Report of Dam Safety Assessment of Coal
Combustion Surface Impoundments
Alliant Energy
M.L. Kapp Power Station
Clinton, IA

AMEC Project No. 3-2106-0183.0002

December 2010

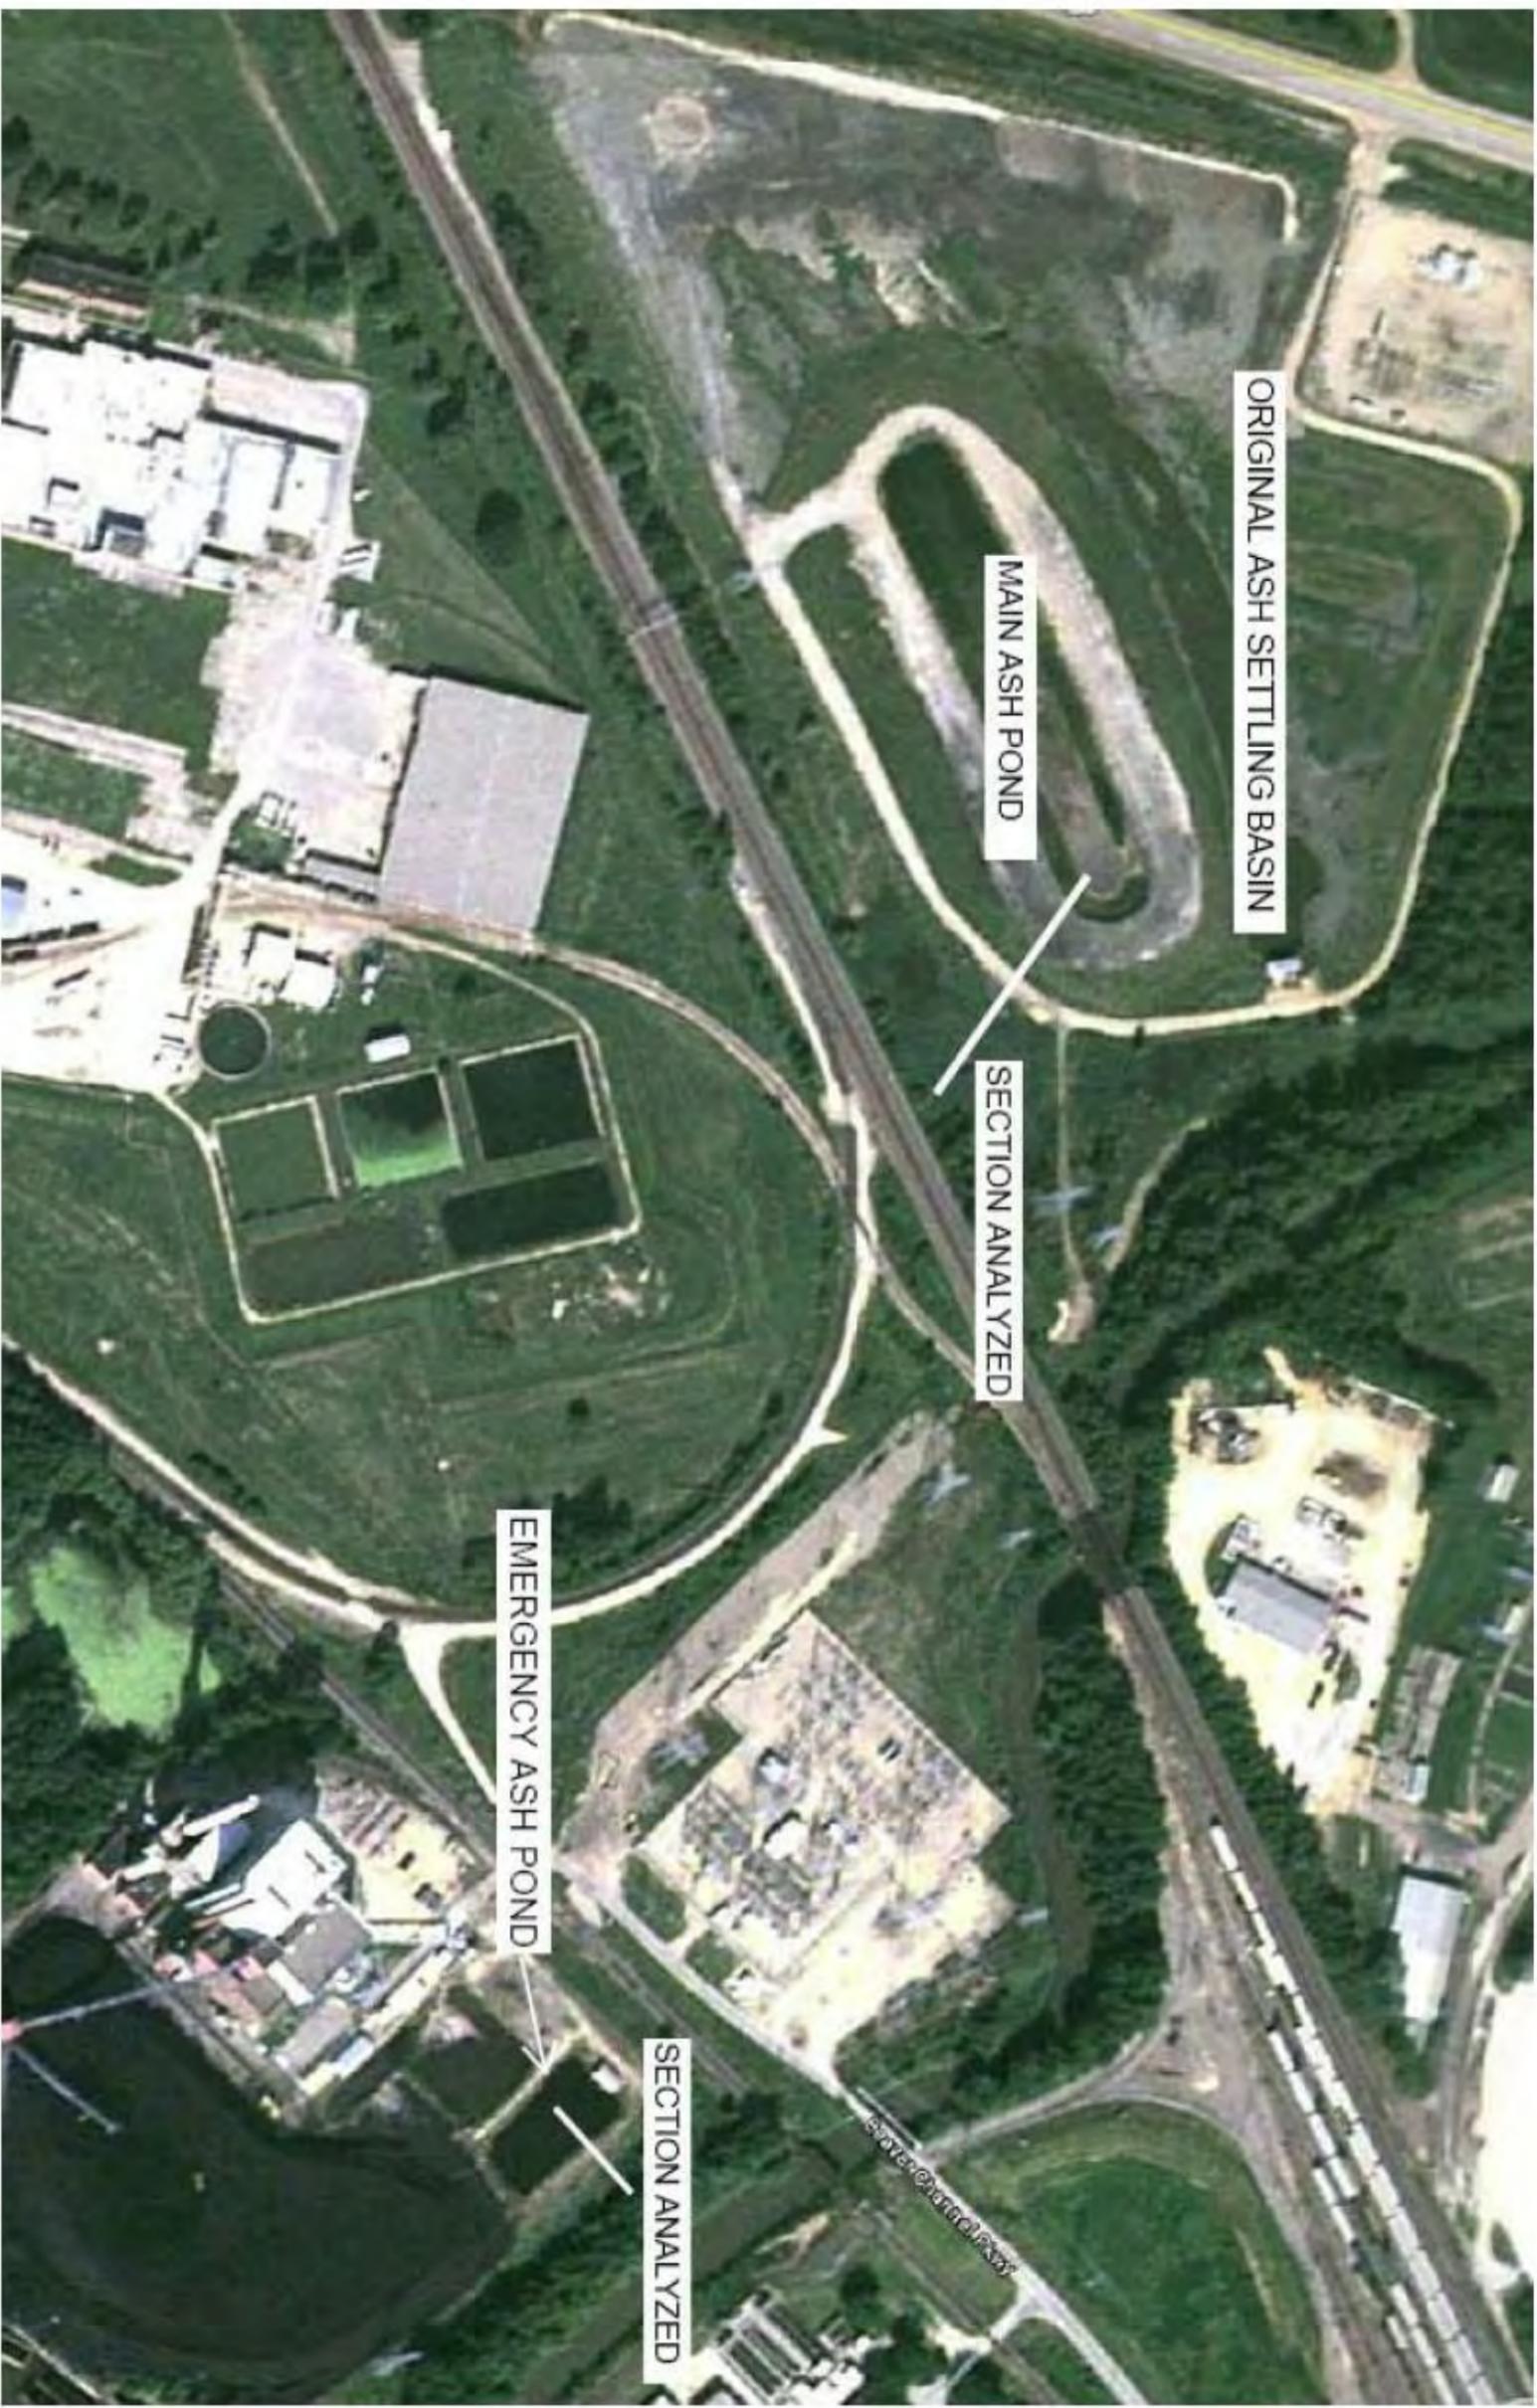
Sargent & Lundy evaluated the overall stability of the dams by reviewing cross sections and previously collected drilling data for their study, as shown on Figure 7. Sargent & Lundy notes the cross sections selected for analysis “were estimated to present the most critical stability conditions for dike stability around the ponds”. The slope stability analyses were performed using SLOPE/W program version 5.211. Minimum acceptable factor of safety (FS) values for the static, seismic and the rapid drawdown conditions analyzed in this calculation were 1.5, 1.15 and 1.1 to 1.3, respectively. Sargent & Lundy stated in their report:

Therefore, Sargent & Lundy’s slope stability analyses included static and seismic (pseudo-static) conditions only for the downstream (exterior) dike face for the Main Ash Pond, and the study included static and seismic (pseudo-static) conditions for the downstream dike face and rapid drawdown condition for the interior face for the Emergency Ash Pond. For their study, Sargent & Lundy utilized the soil borings, B-1 and B-2 performed in 1994 by Huntingdon Engineering & Environmental, located adjacent to the Emergency Ash Pond and Main Ash Pond dikes, respectively. Table 7 and Table 8 provide a summary of the soil properties utilized in Sargent & Lundy’s report. We understand the two borings utilized by Sargent & Lundy for the basis of their slope stability analyses were drilled adjacent to the existing dikes; therefore, we understand the information utilized for the dike material was based on available construction documents.

In the opinion of the assessing professional engineer, the analysis should consider all critical stages over the life of the pond including pond full conditions. These conditions would need to be determined in conjunction with the hydraulic recommendations above. The hydrologic and hydraulic analysis will provide maximum water levels in the pond and a phreatic surface through the embankment. A rapid-drawdown should be performed for downstream embankment in relation to flooding of the Mississippi River. Since Sargent & Lundy's borings did not penetrate the CCW material, and documentation pertaining to the CCW's degree of compaction is not known, the friction angle value used for the CCW in the analysis appears to be slightly high for
